Bulletin Type.....: Field Fix (M)
Bulletin No.....: TS-M124
Bulletin Name.....: T-bolt clamp replacement
Bulletin Ref No.....: 700003234
PQR No.....: 500000006103
Release Date.....: 11.09.2017
Expiry Date.....: 11.09.2018
Vehicle Model.....: TS45
Fiat Rate Code.....: TSM124
Flat Rate Time.....: 50'

Subject: T-bolt clamp replacement

Summary : This technical service bulletin gives the instruction about how to replace the T-bolt clamp for TS 45 vehicles

Figure-1

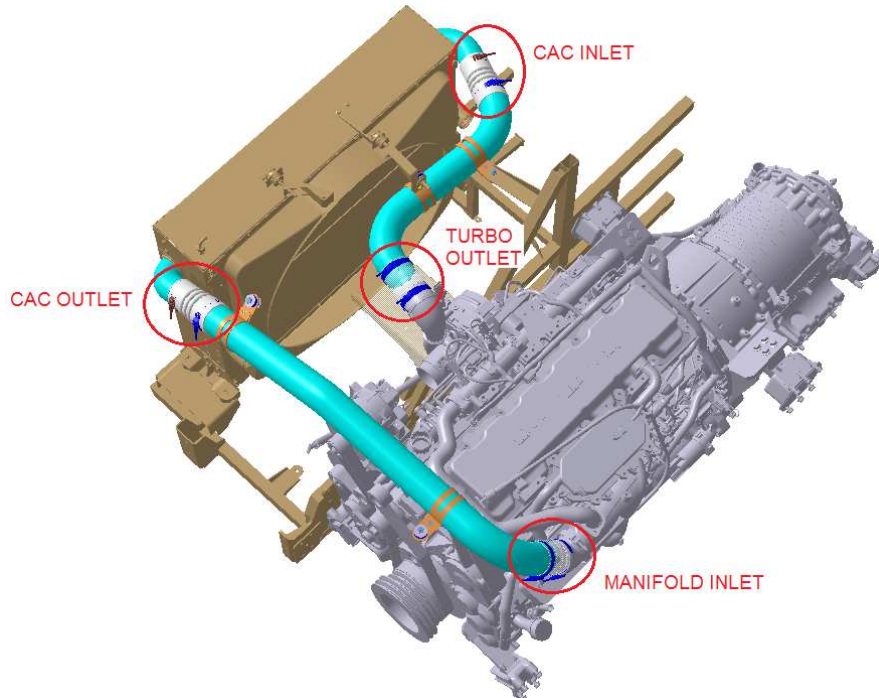
- 1- Location of the clamps to be replaced, see in. (see. **Figure-1**).

Figure-2

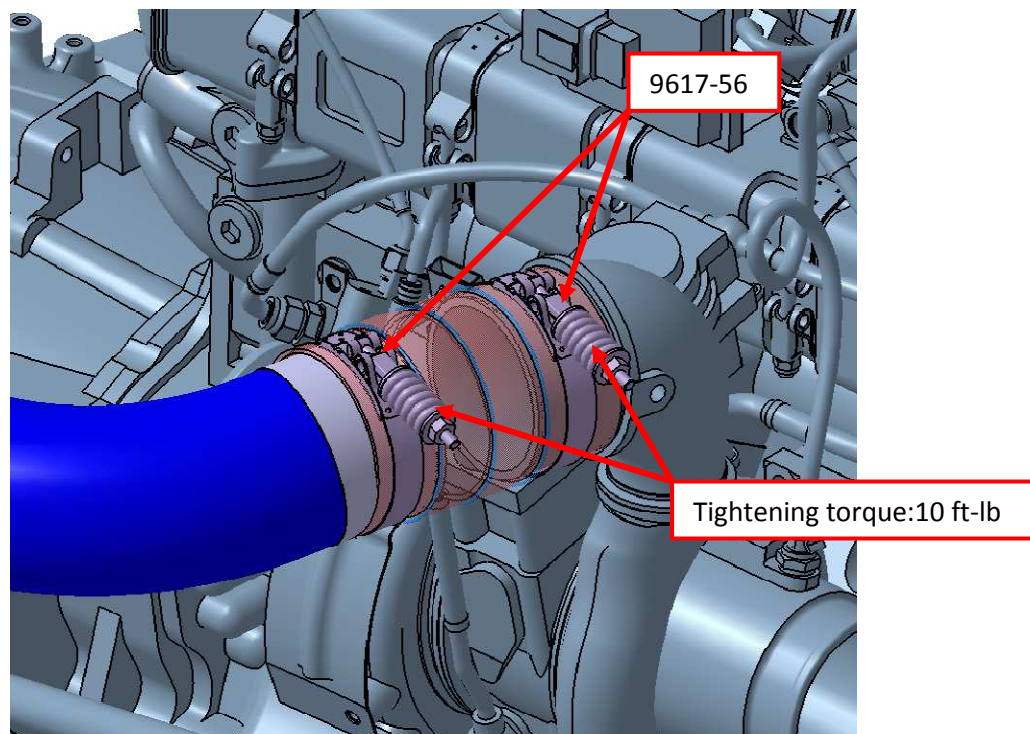
- 2- Replace the clamps indicated below with the new clamps.(Turbo outlet) (see. **Figure-2**).

Figure-3

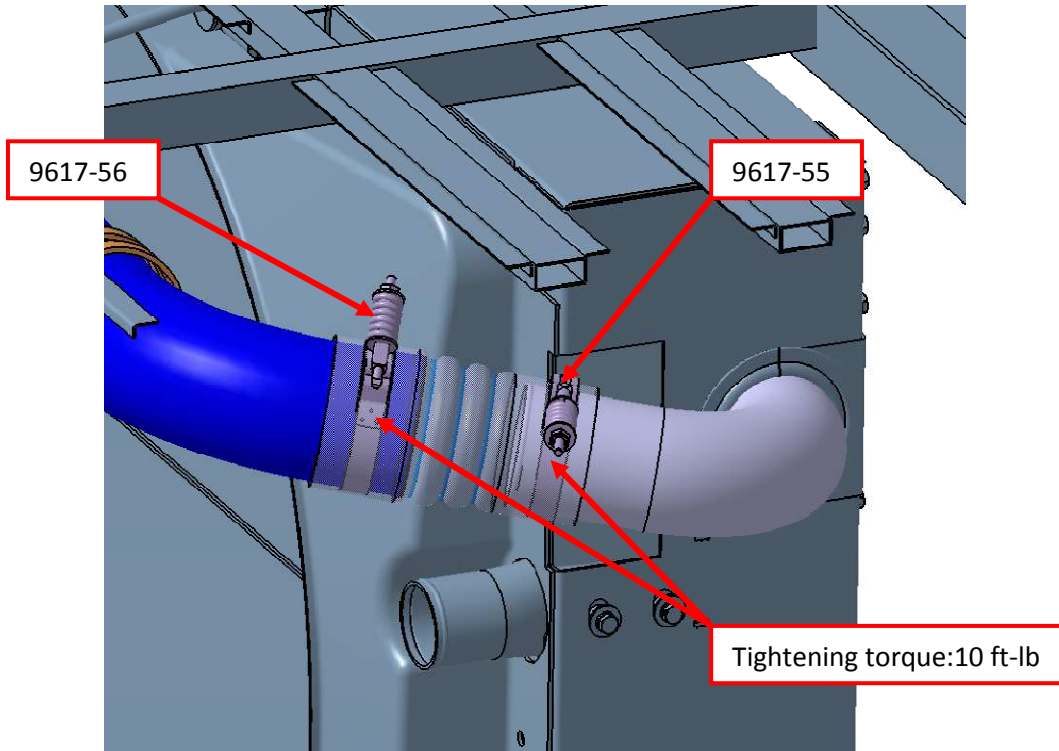
3- Replace the clamps indicated below with the new clamps.(CAC inlet). (See. Figure-3).

Figure-4

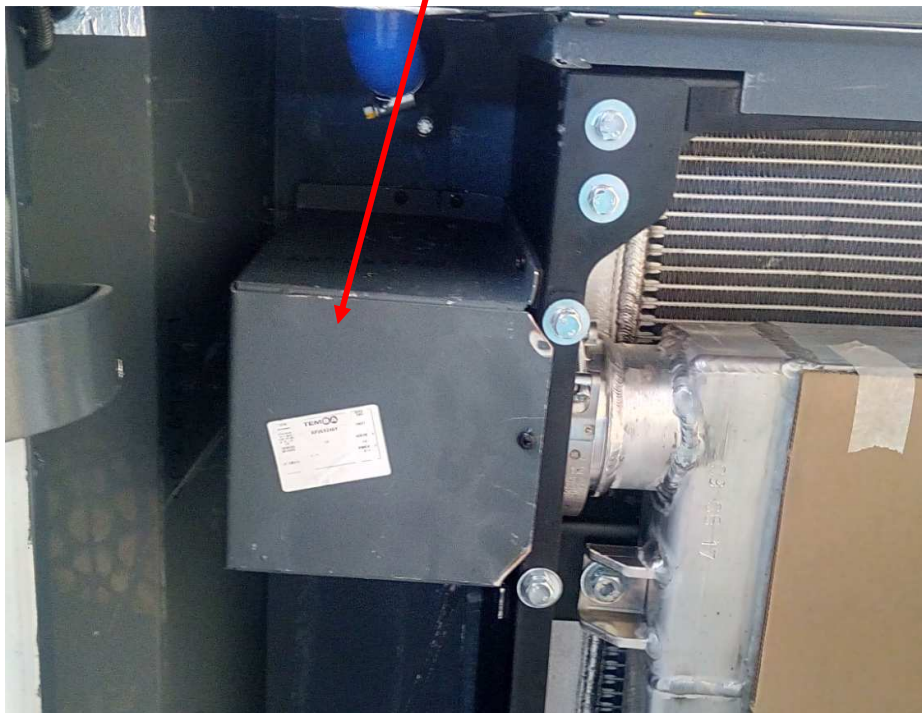
Note: In order to replace CAC Inlet clamps remove the cover indicated below. (See. Figure-5).

Figure-5

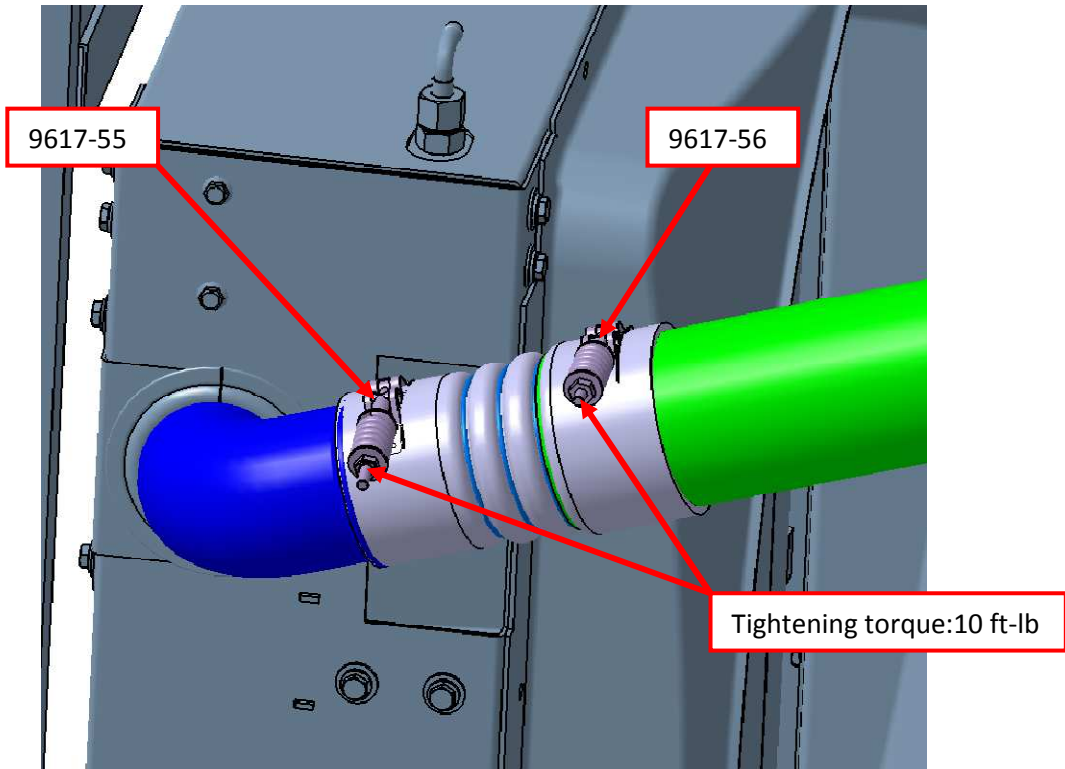
4. Replace the clamps indicated below with the new clamps.(CAC outlet). (See. Figure-5).

Figure-6

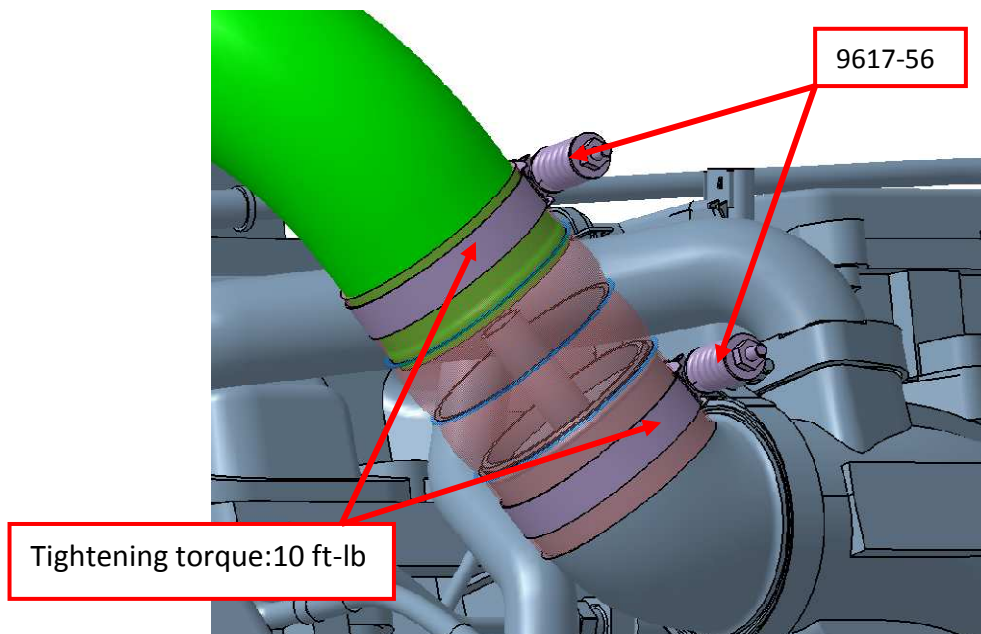
4- Replace the clamps indicated below with the new clamps.(Manifold inlet). (See. Figure-6).
